| TYPE | YEAR | PROJECT NO. | SHEET NO. |
|---|---|---|---|
| R.O.W. | 2015 | HSIP-106(33) | 20 |
| CONST. | 2017 | HSIP-106(33) | 30 |

S.R. 106 WILLIAMSON CO.

BEGIN STA. 110+50.00
END STA. 111+50.00

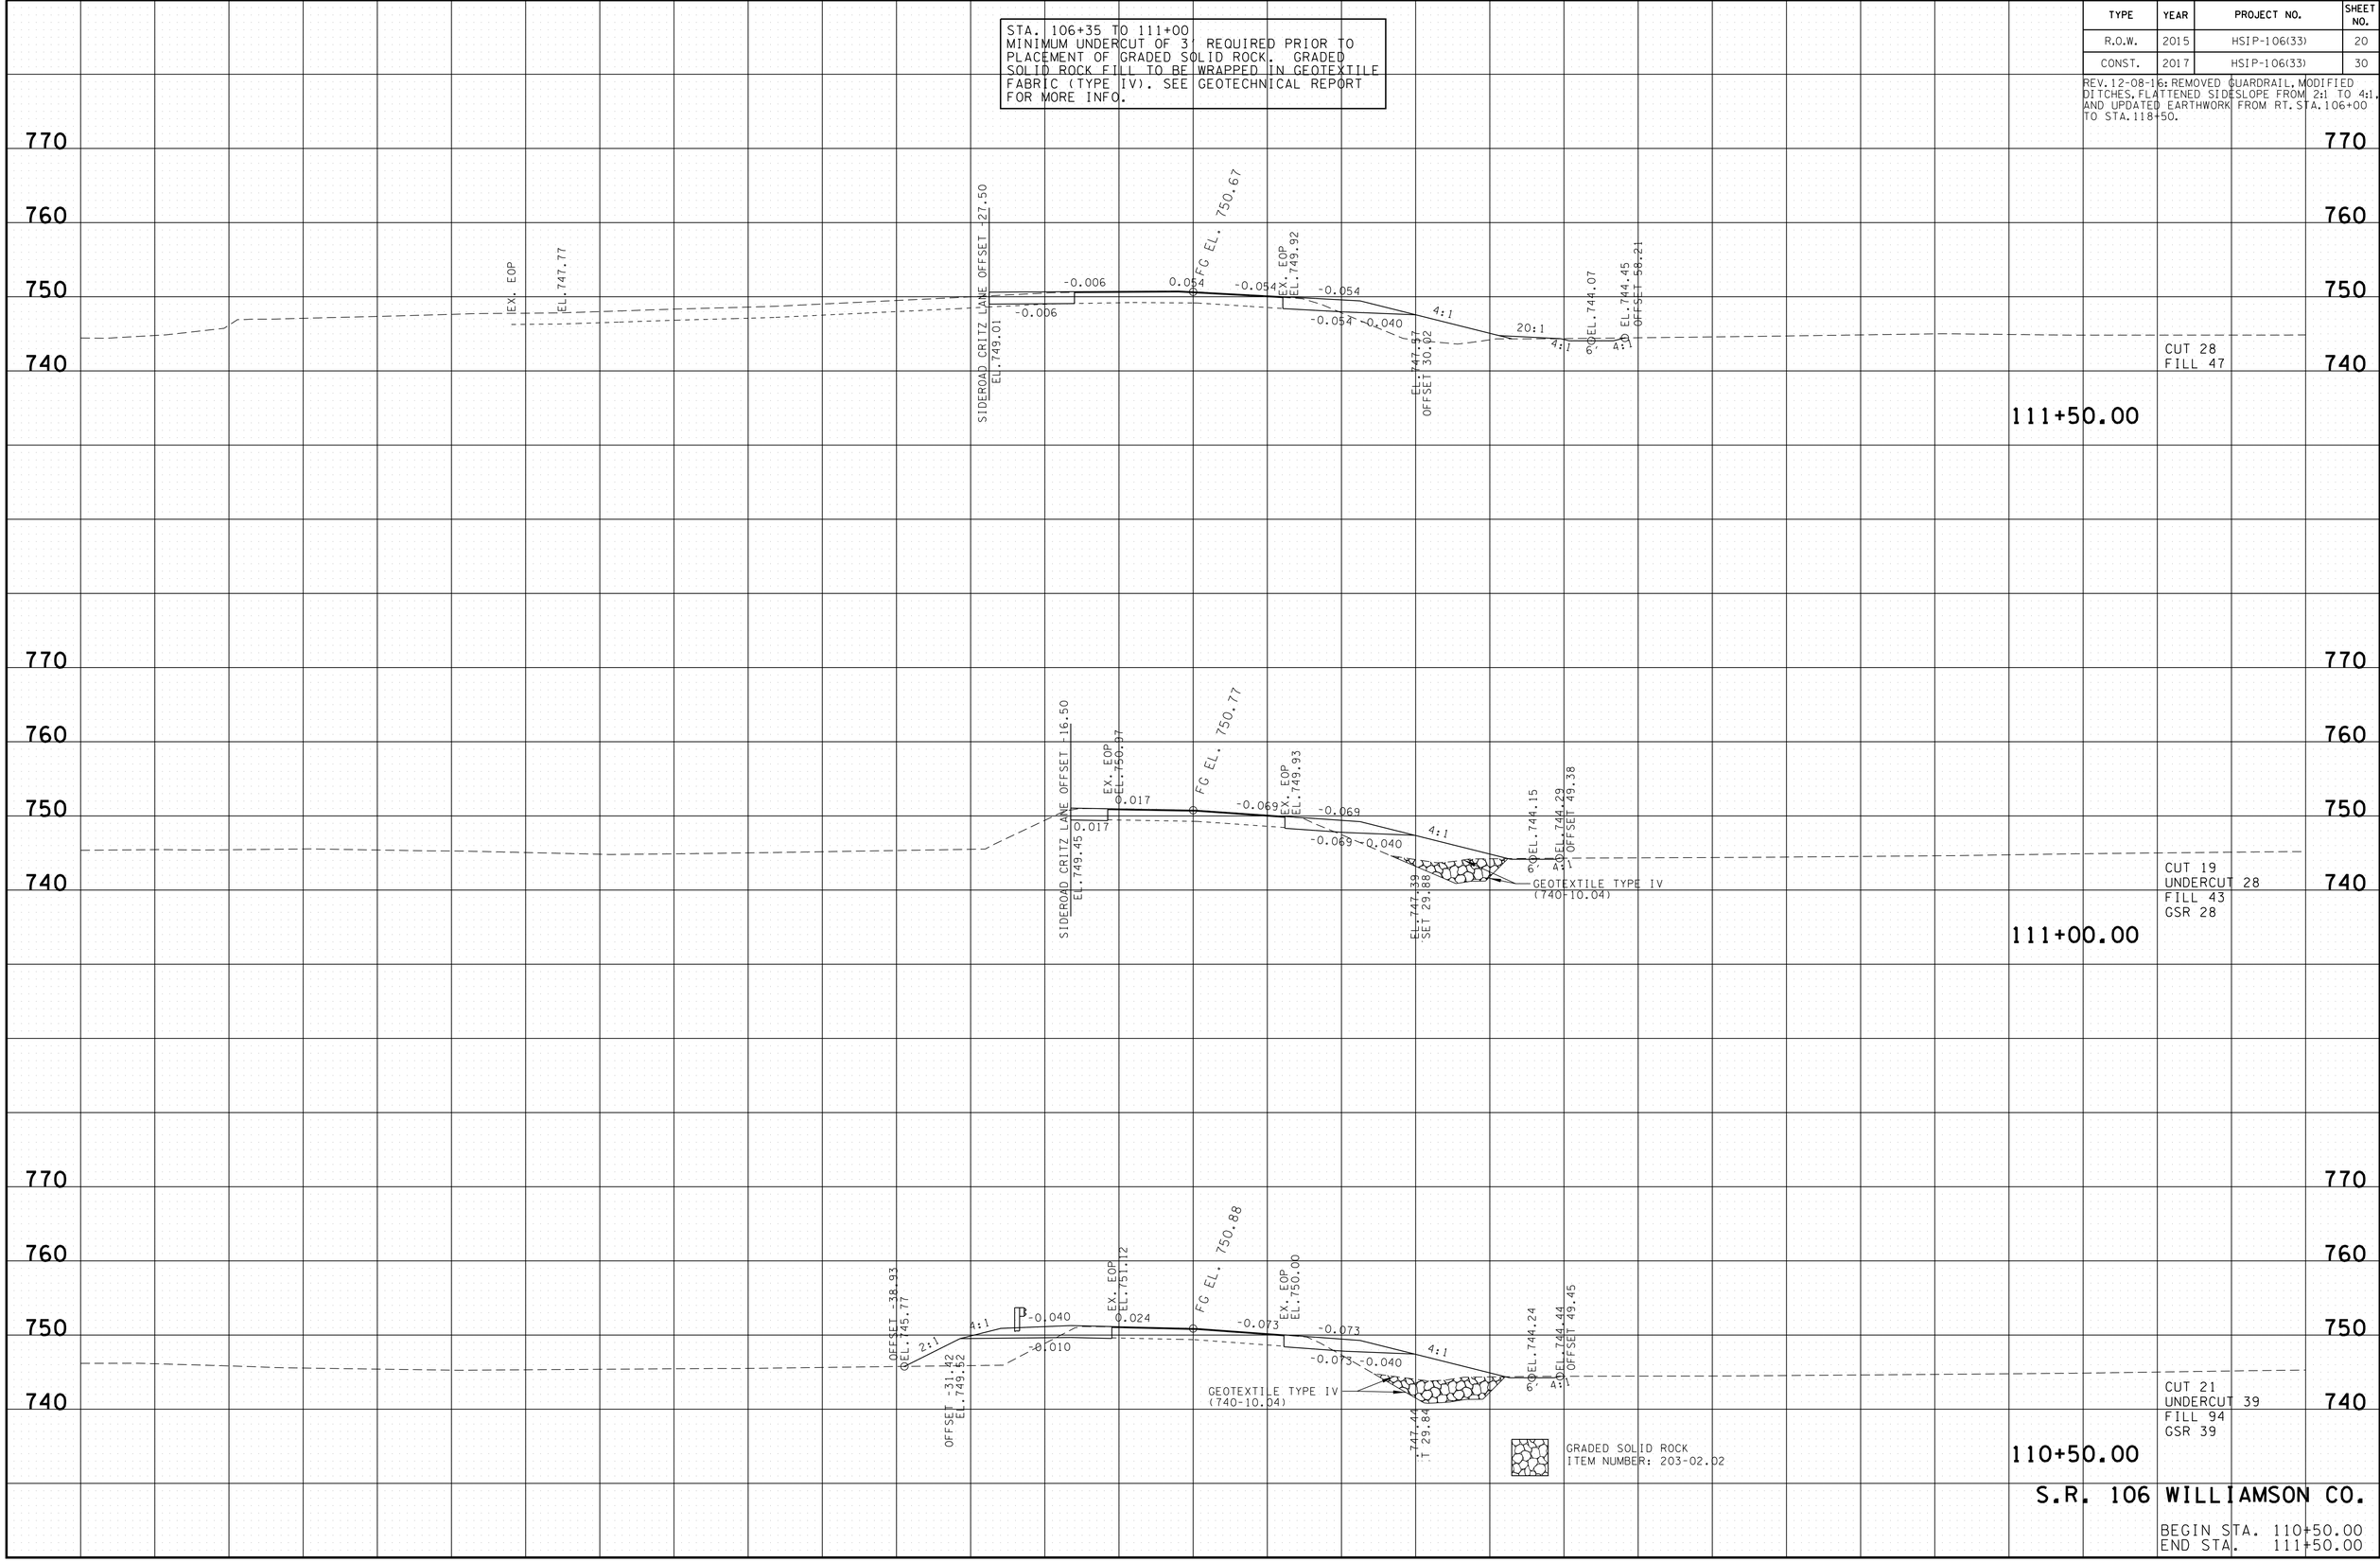
REV. 12-08-16: REMOVED GUARDRAIL, MODIFIED DITCHES, FLATTENED SIDESLOPE FROM 2:1 TO 4:1, AND UPDATED EARTHWORK FROM RT. STA. 106+00 TO STA. 118+50.

STA. 106+35 TO 111+00
MINIMUM UNDERCUT OF 3' REQUIRED PRIOR TO PLACEMENT OF GRADED SOLID ROCK. GRADED SOLID ROCK FILL TO BE WRAPPED IN GEOTEXTILE FABRIC (TYPE IV). SEE GEOTECHNICAL REPORT FOR MORE INFO.
